To: Planning Committee
From: Brian J. Jackson, MCIP
Director of Development

Date: January 12, 2012
File: RZ 09-466062
08-4105-20-AMANDA
#/2012-Vol 01

Re: Application by Oris Development (Kawaki) Corp. for an OCP Amendment to London/Princess Sub-Area Plan and for Rezoning at 6160 London Road and 13100, 13120, 13140, 13160 and 13200 No. 2 Road from "Light Industrial (IL)" to "Commercial/Mixed-Use (ZMU20) – London Landing (Steveston)" and "School & Institutional (SI)"

Staff Report

LEVEL L1 PLAN

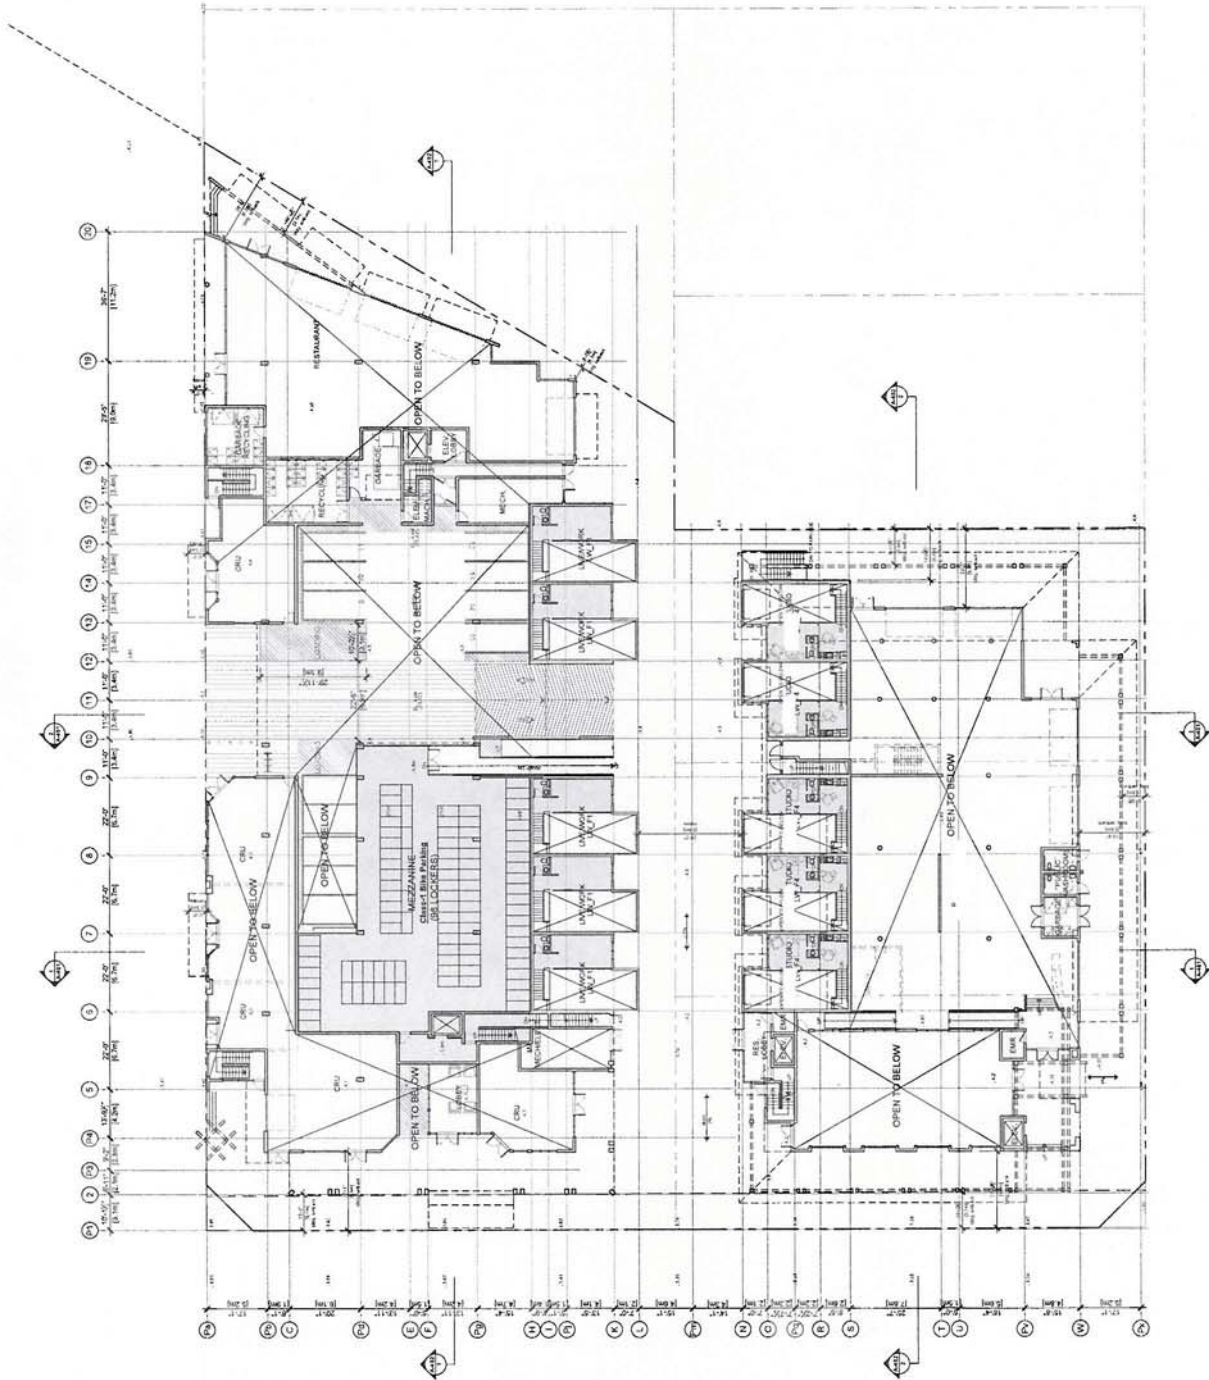
- Identifying dimensions and extent of encroachments onto Dyke Road ROW and London Road Public Rights of Passage (PROP) ROW's.
- Adjustments to Level L1 Plan of Building A (East building) to resolve aspects associated with loading space maneuvering.

FUTURE
ALIGNMENT
OF DIKE

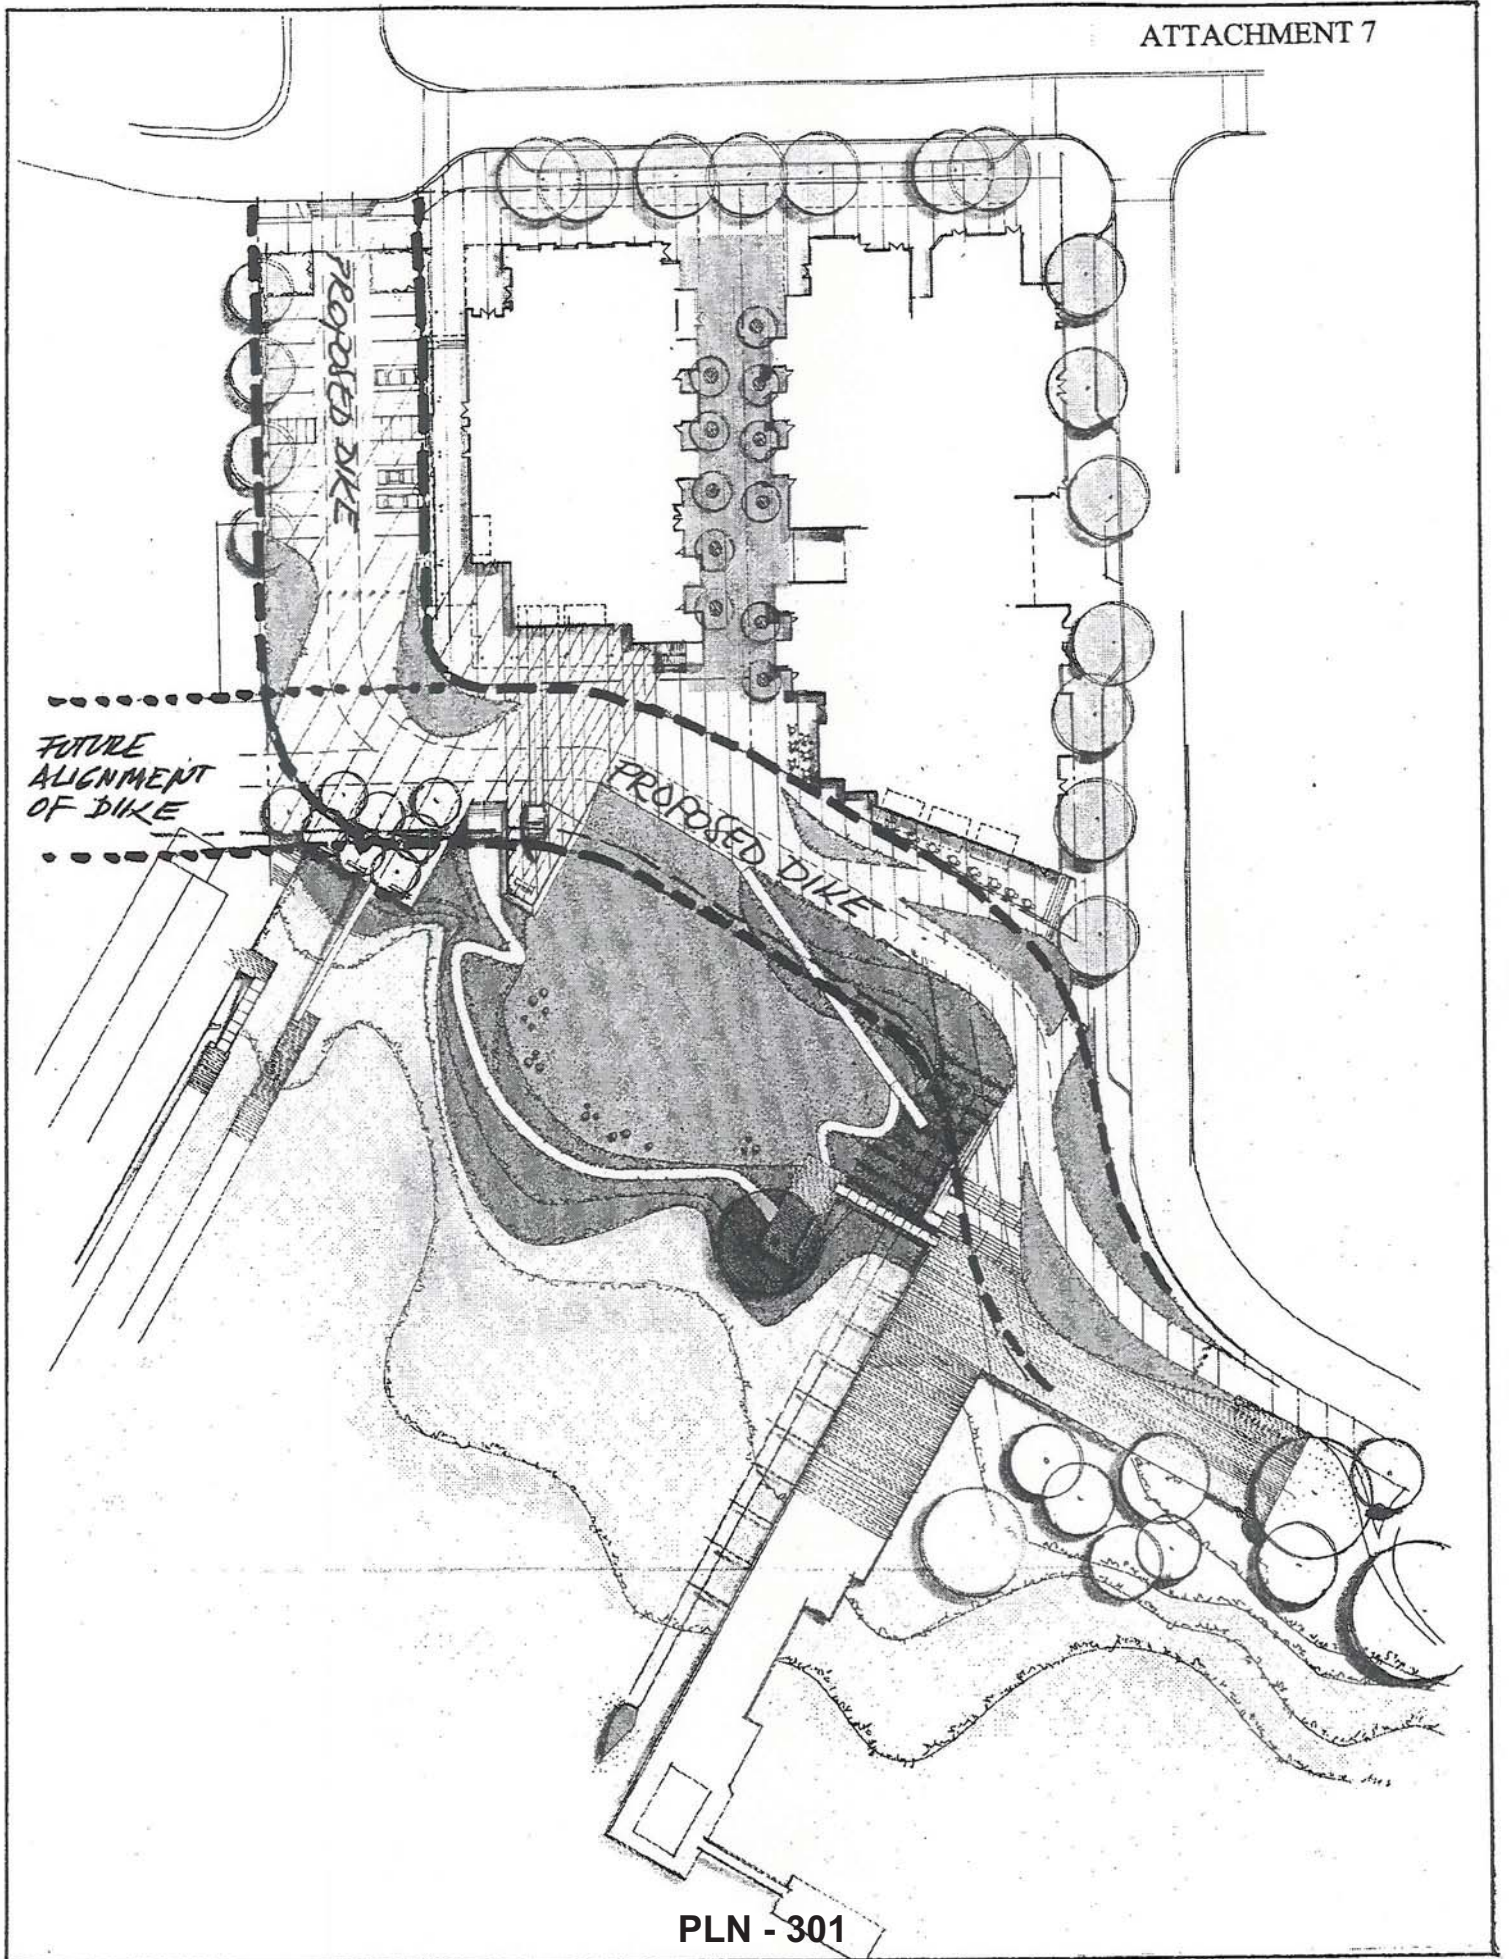
Staff are currently working on a Dike Master Plan that will provide direction and clarity on required medium to long-term dike improvements in the Steveston area. To support the timeliness required by development, Staff are recommending the above dike realignment and will insure that it is incorporated into the Dike Master Plan.

The dyke will be built to Provincial standards with a crest elevation of 4.7 m by the developer. Any potential fill/enhancements required along the shoreline corridor as a result of realigning and raising the elevation of the dyke will be addressed and resolved with the appropriate Government agencies. Aspects associated with any required remediation planning and remediation work, as required by the Ministry of Environment, will need completion prior to a Final Occupancy Permit, as per Rezoning Considerations (**Attachment 6**) concurred by the developer.
